## **ADDENDUM # 1**

**RE:** Turbeville Branch Library  
Turbeville, S.C.  
CGD Project No. 22067

**DATE:** September 19, 2025

7 WALL SECTION - RAMP  
A503 1" = 1'-0"

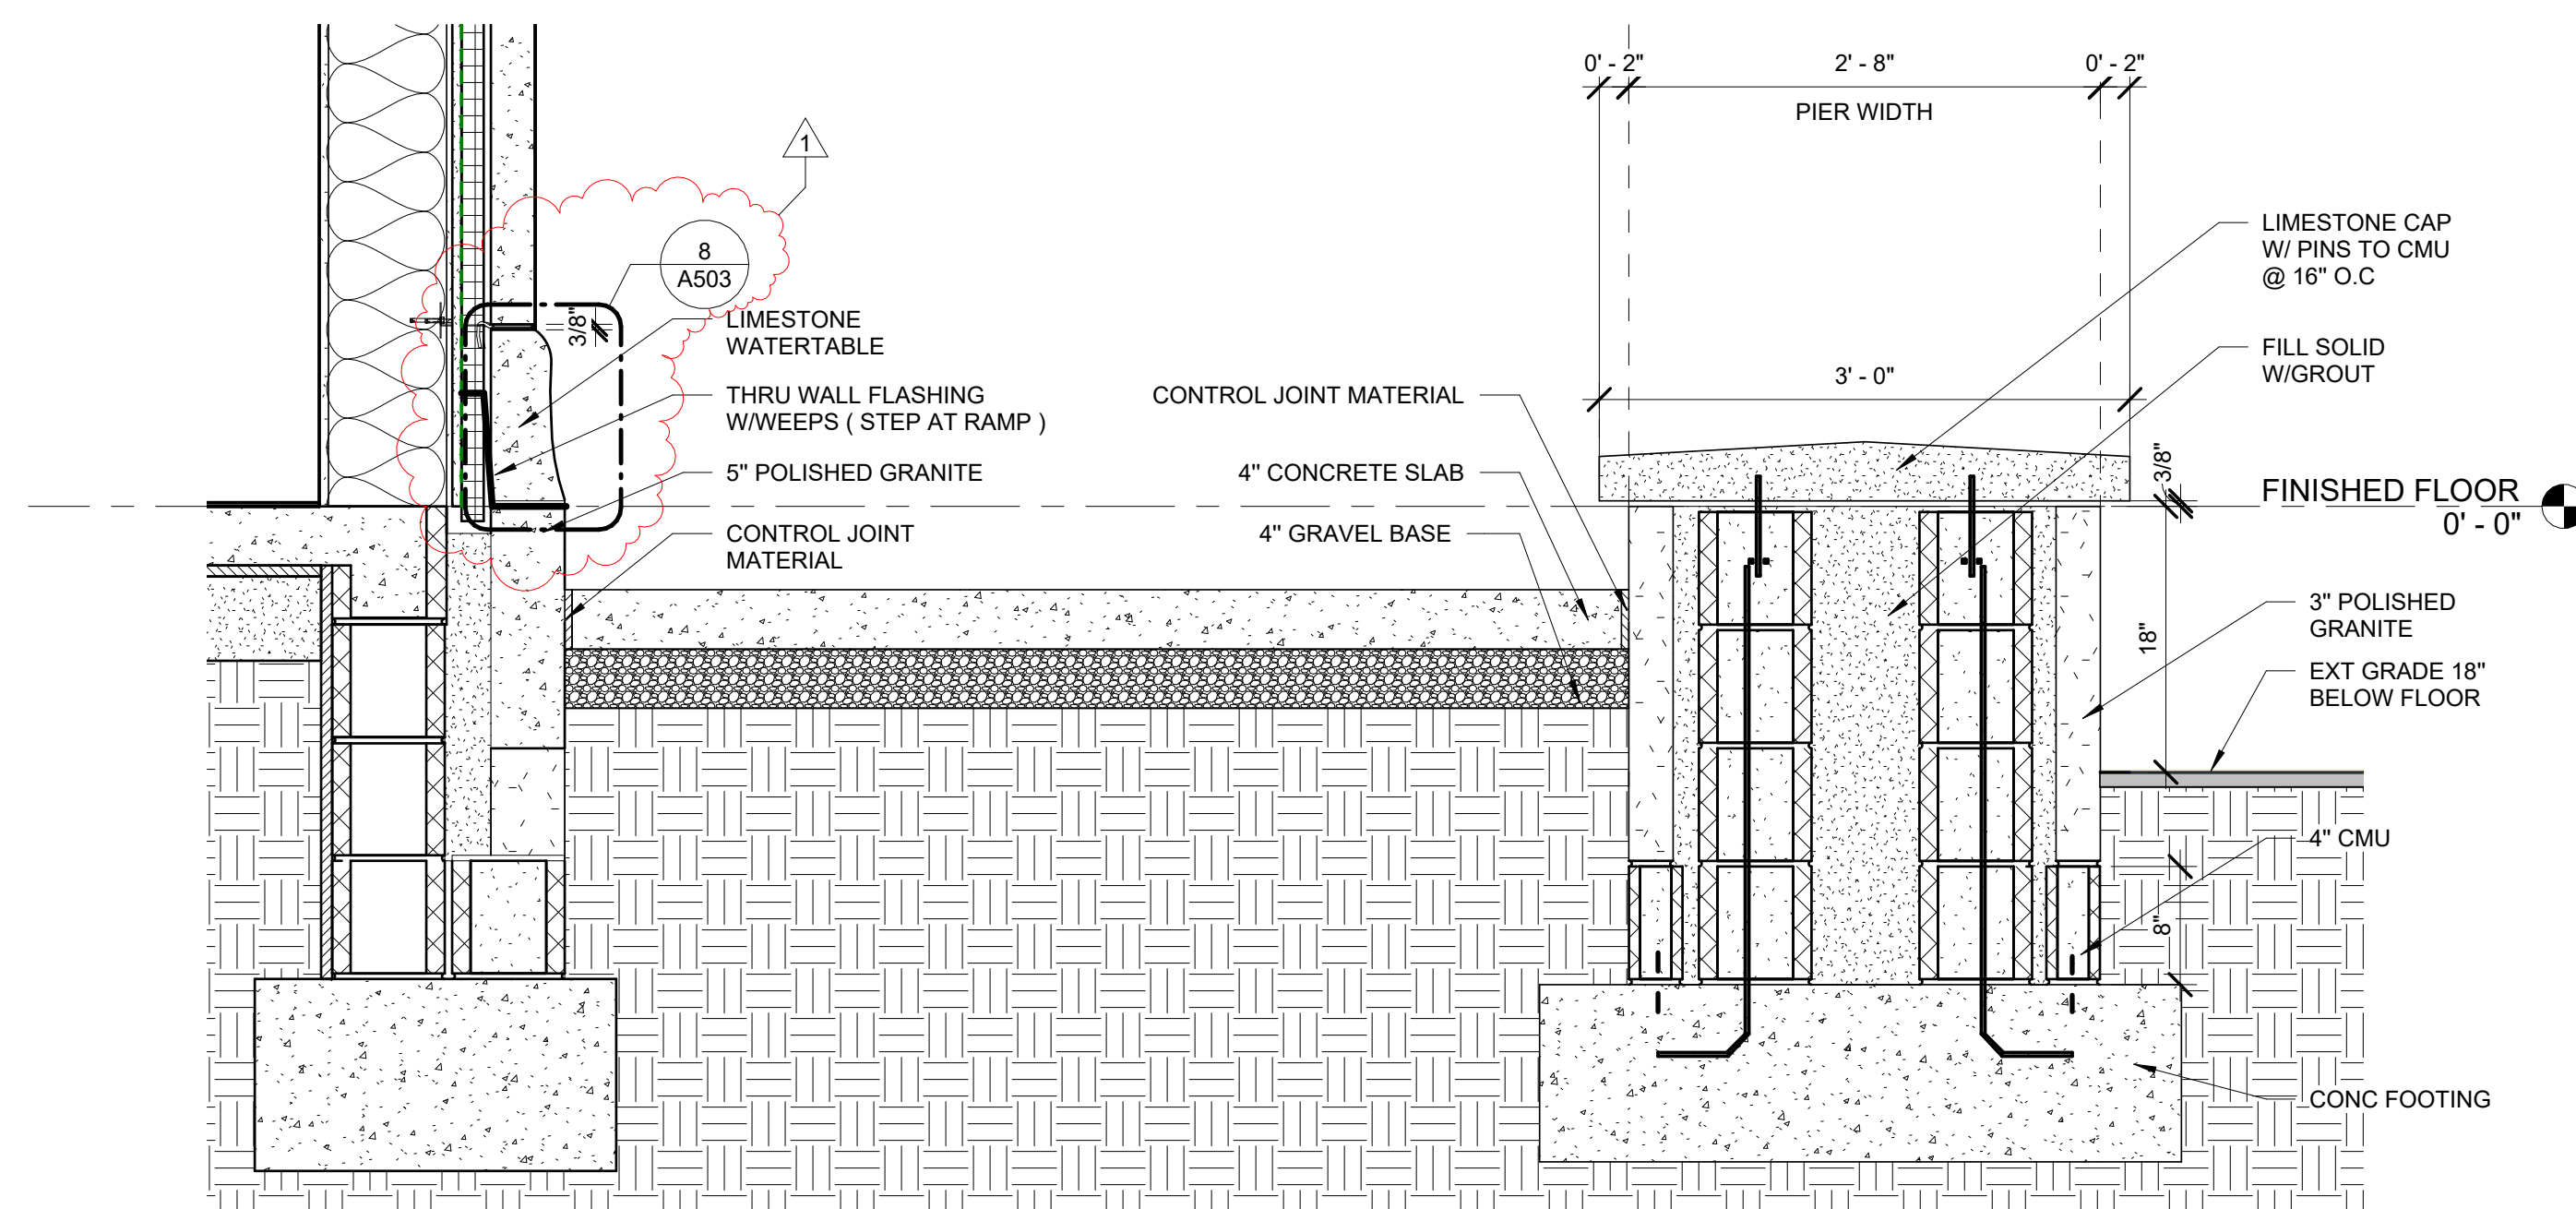
**D2    Sheet A101, A201, A301, A302, A401, A501, A502, A503, A601, A801:**

See clouded drawing revisions, noted as Mark 1, dated 9/17/25. All revised sheets are attached to this addendum.
